SEAD-59 AND SEAD-71

PROJECT SCOPING PLAN FOR PERFORMING A CERCLA
REMEDIAL INVESTIGATION/FEASIBILITY STUDY (RI/FS) AT
THE FILL AREA WEST OF BUILDING 135 (SEAD-59), AND THE
ALLEGED PAINT DISPOSAL AREA (SEAD-71), SENECA ARMY
DEPOT ACTIVITY

APRIL 1997

**PROJECT SCOPING PLAN
REMEDIAL INVESTIGATION/FEASIBILITY STUDY
AT SEAD-59 and SEAD-71
SENECA ARMY DEPOT ACTIVITY
ROMULUS, NEW YORK**

FIGURE 4-4
 LOCATION OF EXISTING AND PROPOSED SAMPLING POINTS AND SURVEYS

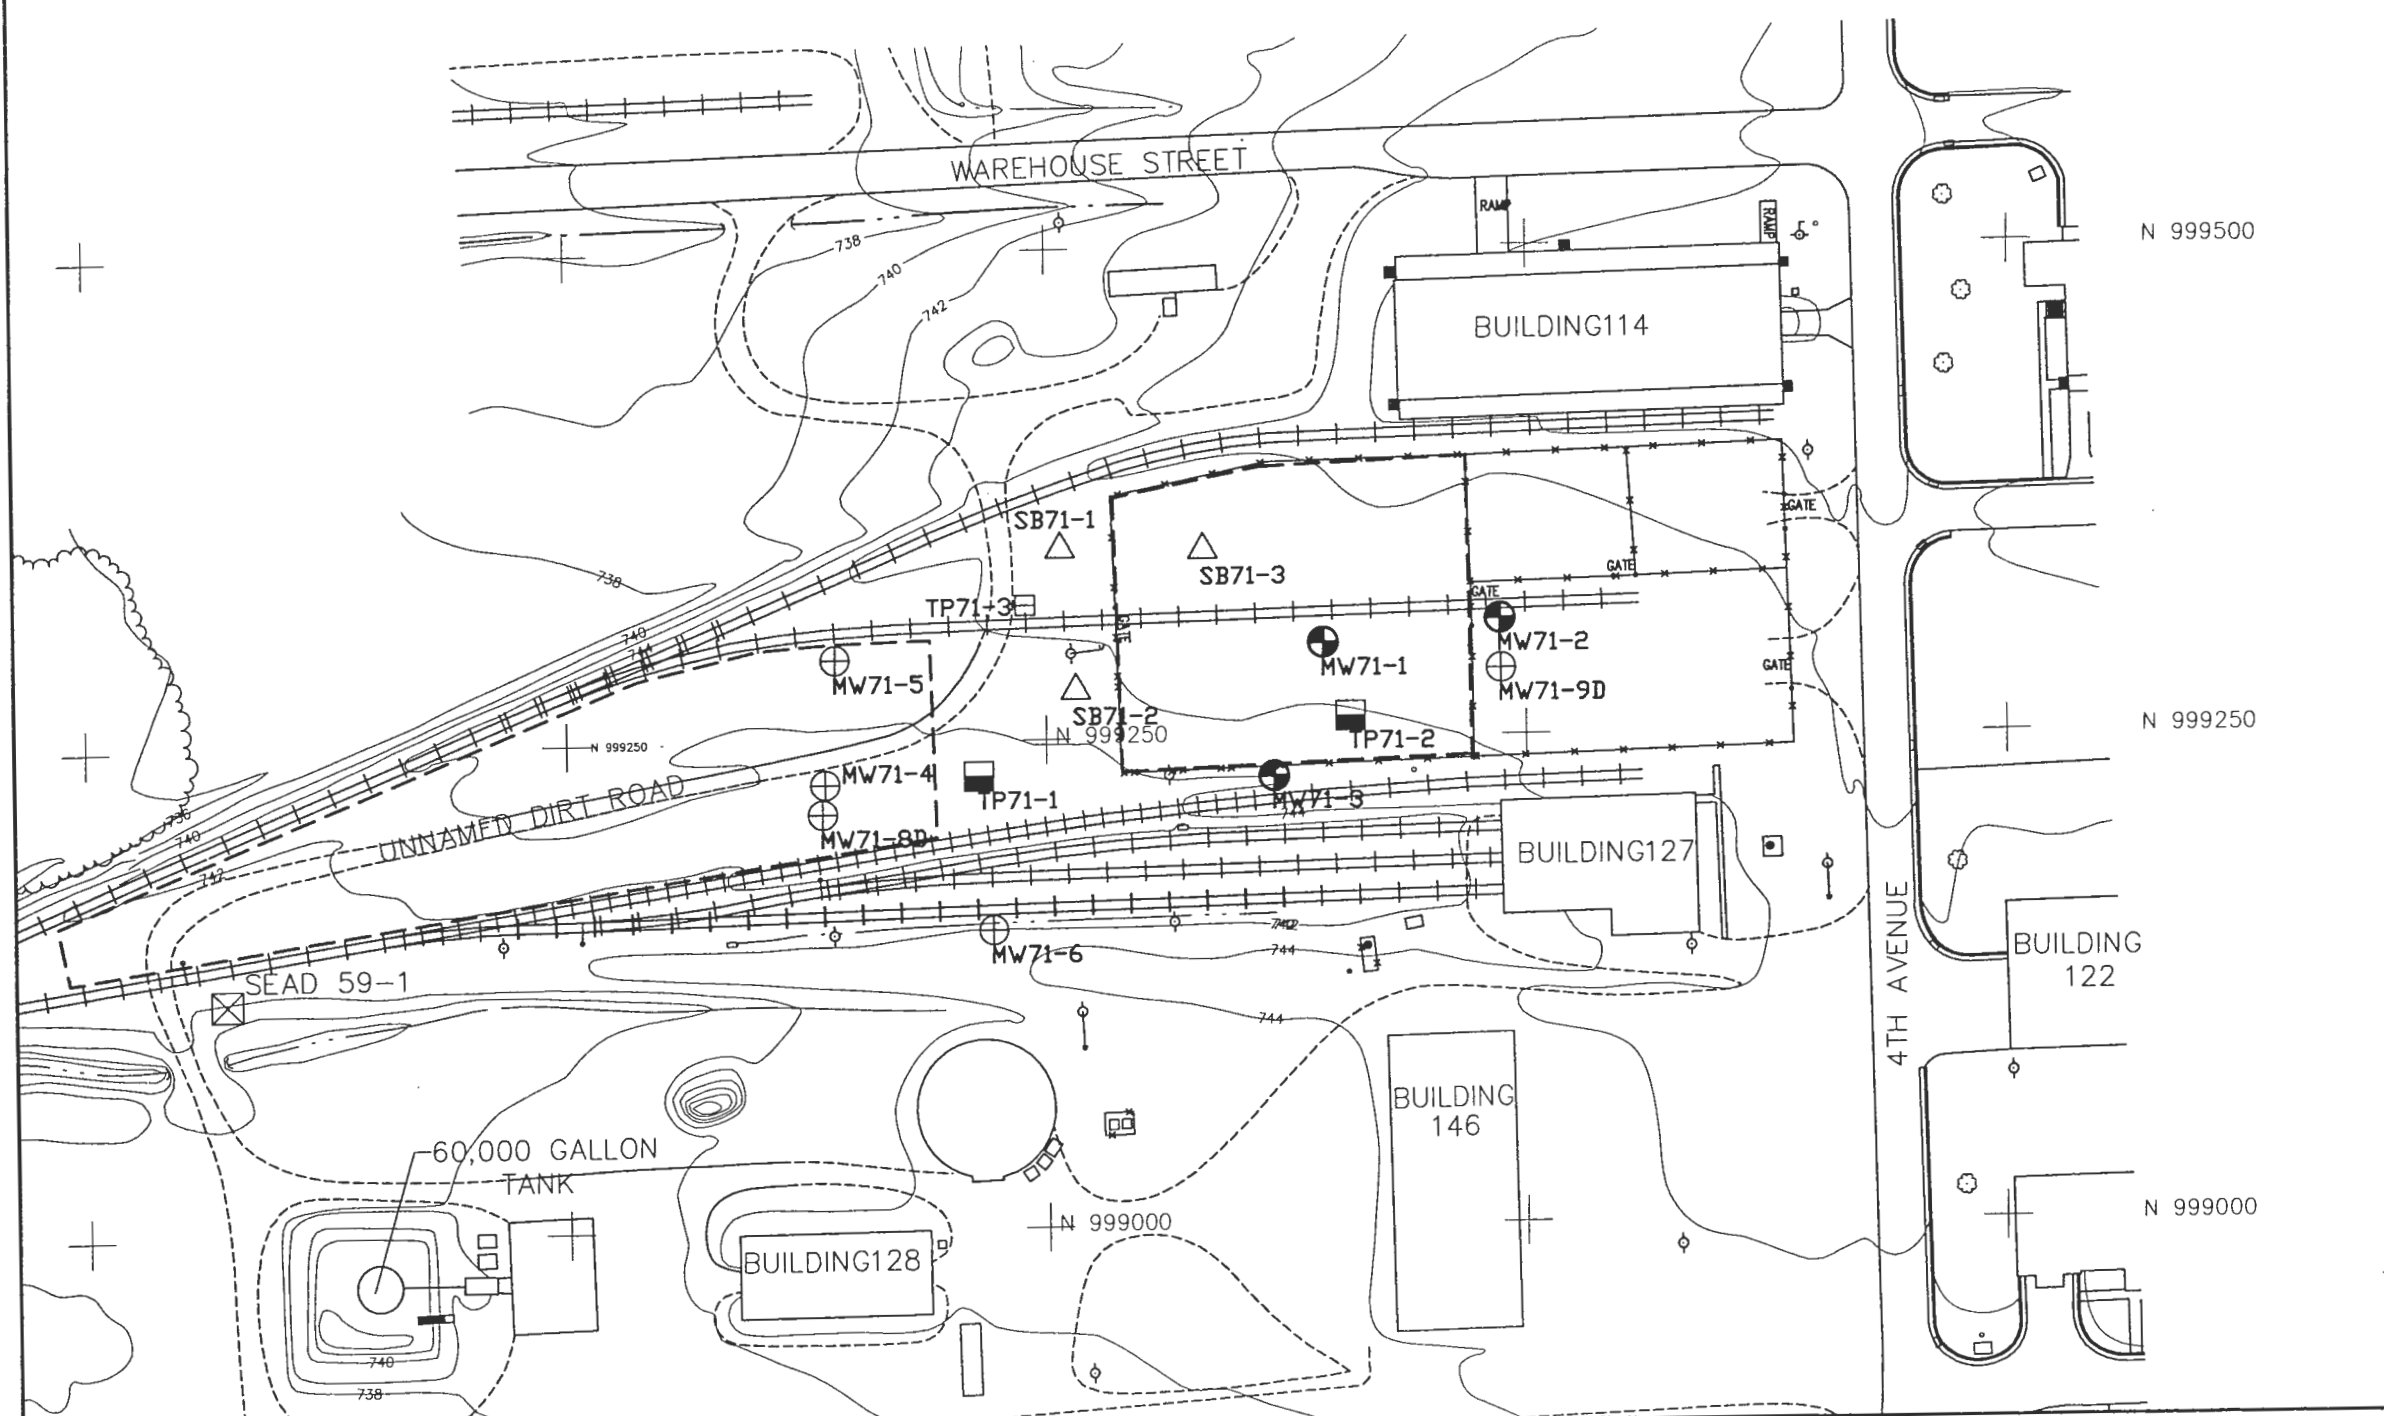
- Comment #18** Figure 4-5: Groundwater contours should be shown on this Figure. Comparison of this Figure with Figure 3-19 indicates that the proposed monitoring wells may only monitor part of the area which is hydraulically downgradient of the SEAD. Figure 3-19 indicates that groundwater flow is to the west-southwest. The proposed monitoring wells are all located to the west of the SEAD. An additional monitoring well should be installed to the south of the rail lines leading to Building 127 to the south of Test Pit TP71-1 to monitor groundwater quality downgradient of the SEAD.

Response #21 Agreed. One upgradient, shallow bedrock monitoring well has been added to SEAD-71. The text on pages 4-22, 4-23, and 4-27 has been modified accordingly, and Table 4-2, and Figure 4-4 have also been updated to reflect this new well.

- Response #18** Agreed. An additional well has been proposed for the location recommended in the comment. But, we do not believe that it is necessary to show the groundwater contours on this map because this would make the map look cluttered and more difficult to read; however, the groundwater contours are shown on Figure 3-15. The new well was added to the text in Section 4.3.3 and it was added to Figure 4-4.

Response #21 Agreed. One bedrock monitoring well was proposed for SEAD-71 to address vertical impacts to groundwater. One bedrock well will be installed in a downgradient location in the west-central portion of the site adjacent to an overburden well. This well, and the three bedrock wells at SEAD-59, will be used to define the direction of groundwater flow in bedrock for this area. The text in Section 4.3.8 was revised to show this change and the well was added to Figure 4-4 of the Scoping Plan.

The additional GPR survey to be performed in the central and western portion of the site was added to the text in Section 4.3.1 and the location of the GPR geophysical survey is indicated on Figure 4-4. The soil sampling program in Section 4.3.2 of the Scoping Plan was revised and appropriate changes were made to Figure 4-4.
